**DEPARTMENT OF TRANSPORTATION**

Contract #: 04-0120F4Cty: SF/ALA Rte: 80 PM: 13.2/13.9File #: 69.25B**QUALITY ASSURANCE -- NON-CONFORMANCE REPORT****Location:** Changxing Island, Shanghai, China**Report No:** NCR-000062**Prime Contractor:** American Bridge/Fluor Enterprises, a JV**Date:** 30-Jan-2008**Submitting Contractor:** Zhenhua Port Machinery Company, Ltd (ZPMC), Changxing Island**NCR #:** ZPMC-0060**Type of problem:**

**Job Name:** SAS Superstructure

**Subject:** NCR No. ZPMC-0060

WELD NUMBER: MUC-MA107B/C-4A/4B

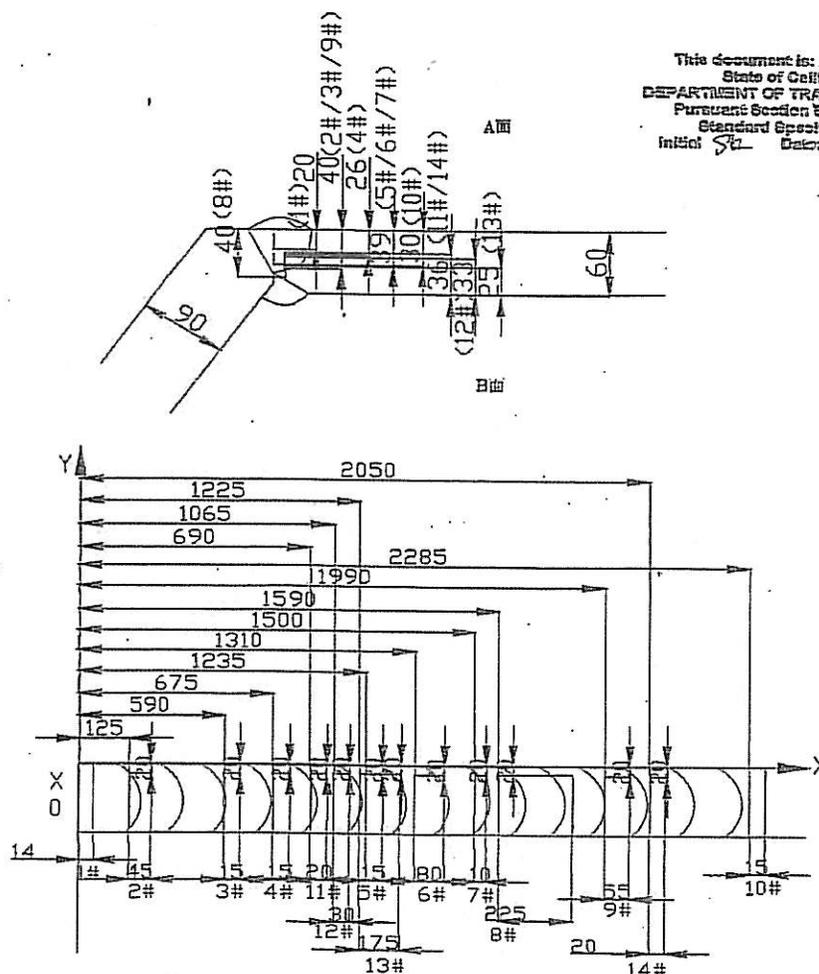
Rejectable indication found by ultrasonic inspection exceeds 10% of the weld size.  
(缺陷焊缝长度超过检测长度的10%。)

- 1. 焊工未严格执行WPS相应的规程。
- 2. 焊道没清理干净。
- 1. Welder didn't strictly inform relative WPS specification.
- 2. Did not clear the weld pass completely.

~~如何~~ How Will QC "IMPROVE" MONITORING?

- 1. Preheat before gouging, the temperature is not below 65°C;
- 2. Gouge off the defect weld completely ,and must prepare a right joint ,the joint details should refer to the approved WPS-repair;
- 3. Grind smoothly the gouged surface;
- 4. Check with MT or other NDT method to make sure the defect remove completely;
- 5. Preheat and the interpass temperature control according to the WPS-repair;
- 6. Postheat after welding ,keep the temperature between 230°and 315°C. Deciding how long the postheat time is according to the gouged depth. Usually per 25mm an hour ,not less than an hour;
- 7. Perform NDE in accordance with according to the approved shop drawing.

WELD NUMBER: MUC-MA107B/C-4A/4B

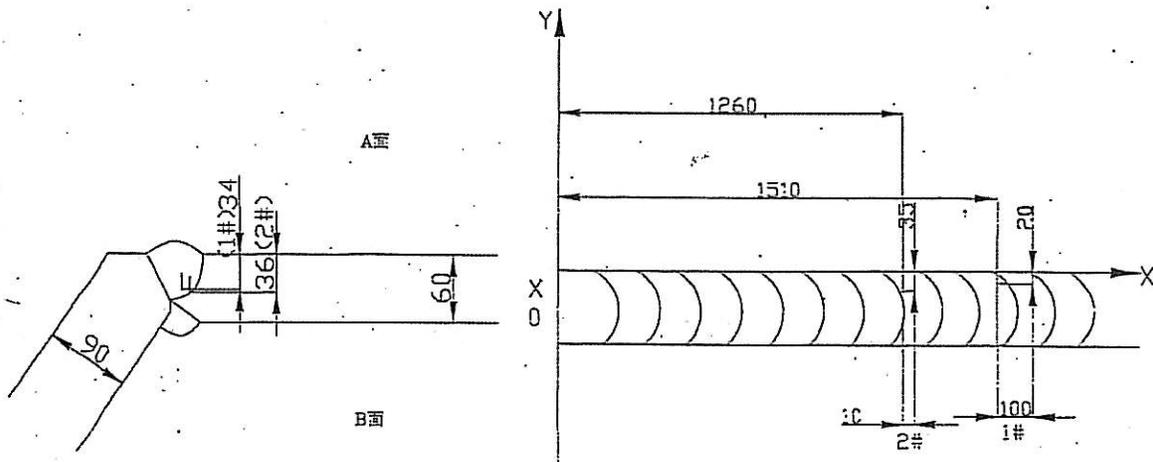
Rejected indication found by ultrasonic inspection is less than the maximum allowance aggregate length. (UT探伤发现的缺陷总长度小于最大允许总长度。) MUC-MA107B/C-4A/4B

1. 焊道没清理干净。
1. Did not clear the weld pass completely.

1. Gouge off the defect weld;
  2. Grind smoothly the gouged surface;
  3. If User's request ,check with MT or other NDT method to make sure the defect remove compelety;
  4. Preheat and the interpass temperature control according to the relative WPS-repair;
  5. Check the welding according to the approved shop drawing.
- 
- 1、 请将有缺陷的焊缝碳刨去除;
  - 2、 将碳刨处打磨光滑;
  - 3、 如用户要求, 用 MT 或其它的无损检测方法证实缺陷被完全清除;
  - 4、 按批准后返修焊接工艺规程 WPS 要求进行预热和控制道间温度;
  - 5、 按图纸要求检测焊缝。

WELD NUMBER: MUC-MA106B/C-4A/4B

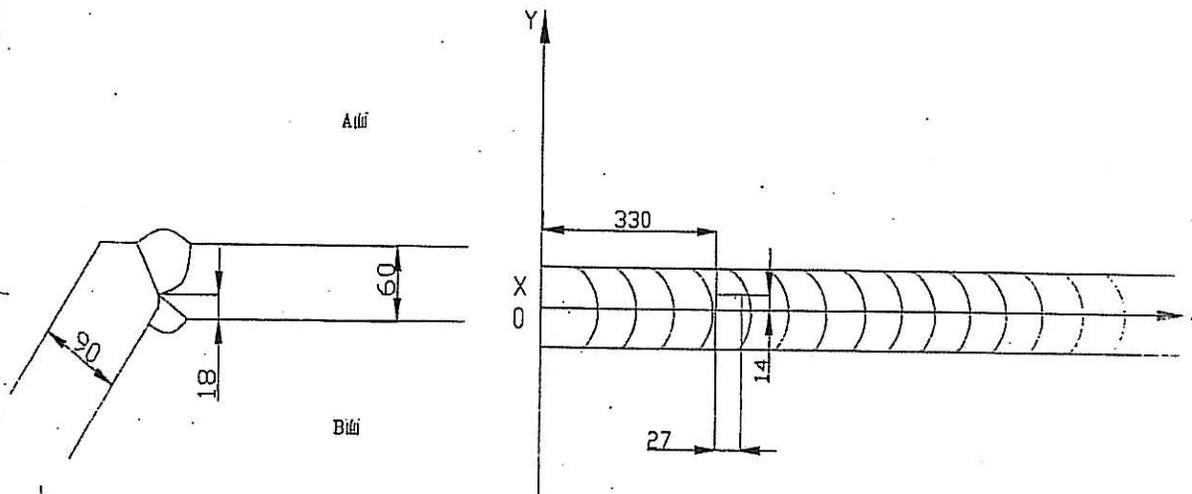
Rejected indication found by ultrasonic inspection is less than the maximum allowance aggregate length. (UT探伤发现的缺陷总长度小于最大允许总长度。) MUC-MA106B/C-4A/4B

1. Did not clear the weld pass completely.

1. Gouge off the defect weld;
2. Grind smoothly the gouged surface;
3. If User's request ,check with MT or other NDT method to make sure the defect remove completely;
4. Preheat and the interpass temperature control according to the relative WPS-repair;
5. Check the welding according to the approved shop drawing.
